Service Manual

CD Stereo System

SA-AK340P
SA-AK340PC
SA-AK340PL
SA-AK340E
SA-AK340EB
SA-AK340EG
SA-AK340EE

Subject : Additional Contents (F61 troubleshooting)

Fig. 1

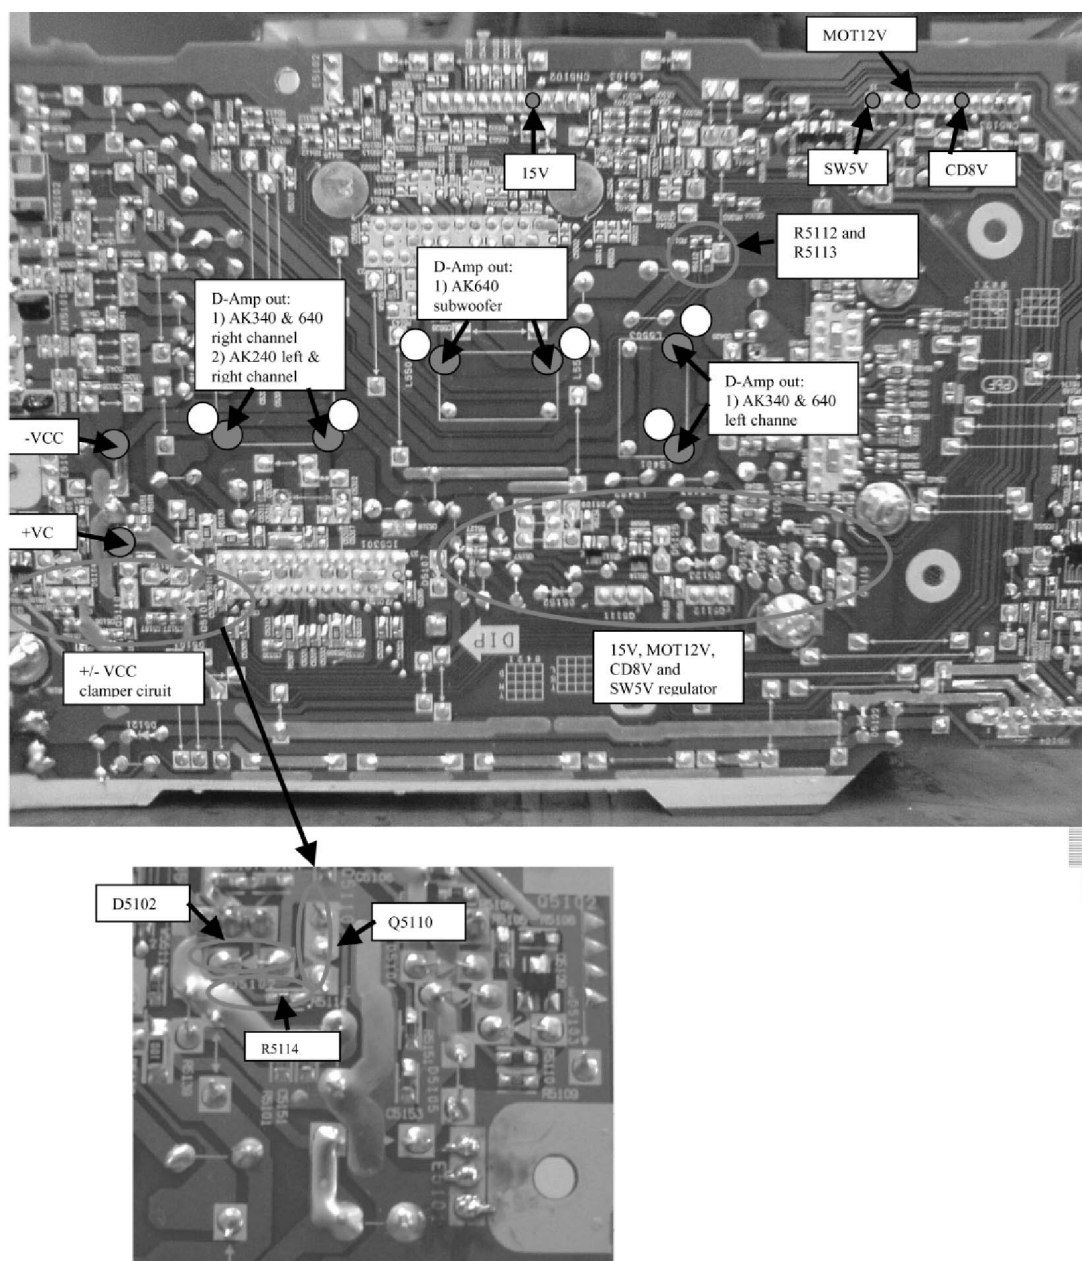
Power ON for a while then only trigger F61. (Symptom always happen)	Check the fan connection to the Main P.C.B. If the fan not proper connected, F61 will trigger when the volume increase.	Re-connect the fan to CN2810.	Refer to Fig 1.
	Check +/- VCC supply balance The +/- VCC supply should be balance. + VCC = +29V and - VCC = - 29V. If the supply is balance, try to reduce the AC supply by 10%. If the symptom does not appear, that means the DC Det line mis-trigger the F61.	- It is due to the resistor tolerance and the DC Det circuit setting is too sensitive to trigger F61. Countermeasure: - Change R5112 & R5113 value as below: - For AK340 change to 390kΩ (Part No. ERJ3GEYJ394V)

Fig. 2

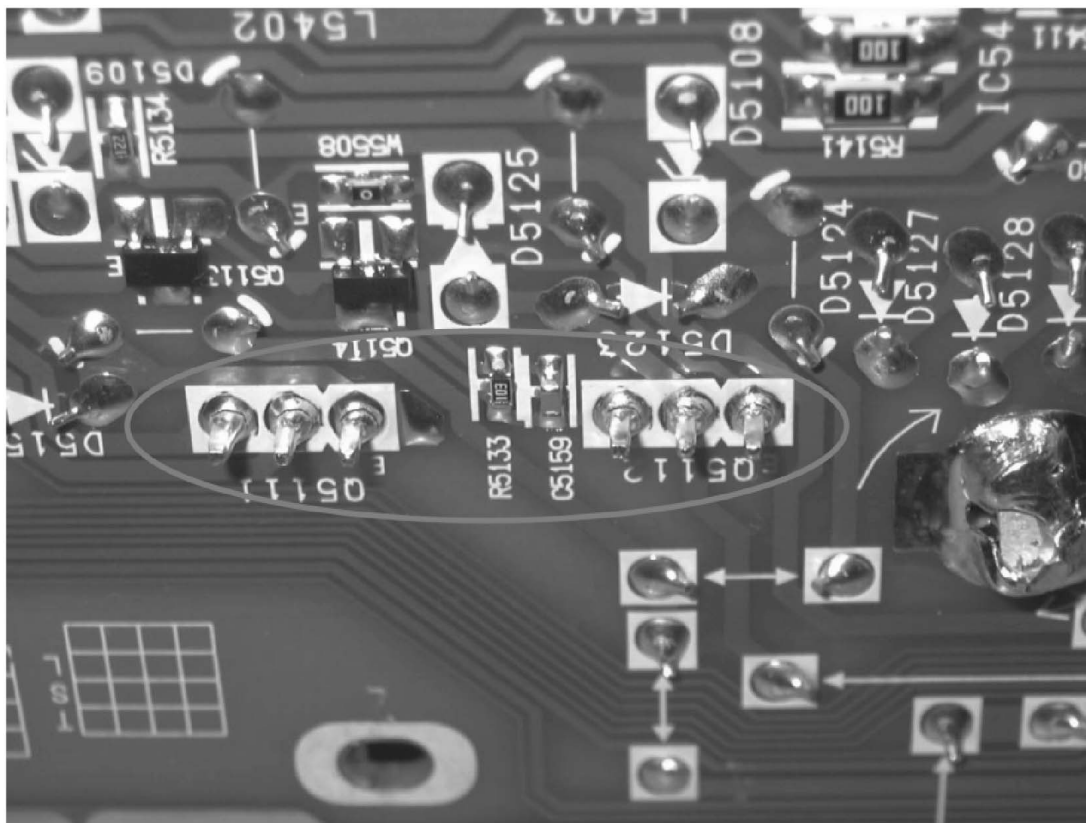
Symptom	Checking Items	Repair Items	Remarks
FL display blinking with abnormal segment when power ON the set or F61	Check the solderability condition of the Power P.C.B. Is there any solder crack at transistor area? (Q5101, Q5102, Q5111 & Q5112)	Touch-up the solder crack area.	Refer to Fig 2.
First power ON display immediate show “F61”.	Check all the supply line +/- VCC if more than +/- 29V, check clamper circuit components especially Q5110, R5114 & D5102. - Check 15V, MOT12V, CD8V, SW5V supply line.	- Change the defective parts. - Q5110 = B1GACFGA0002 - R5114 = ERJ3GEYJ1R8V - D5102 = B0BA02600018	Refer to Fig 1.
	Check speaker output by using multimeter If there is a DC voltage around +/- 29V, check on the pcb, +/- VCC point with every channel output of D-Amp IC, if shorted, that means D-Amp damage already.	- Change the defective D-Amp IC. - point 1 or 2 short to +/- VCC = change IC5301 - point 3 or 4 short to +/- VCC = change IC5401 - point 5 or 6 short to +/- VCC = change IC5501 - IC part no.:C1AA00000755. +VCC = C5101 (+ve leg) - VCC = C5104 (-ve leg)
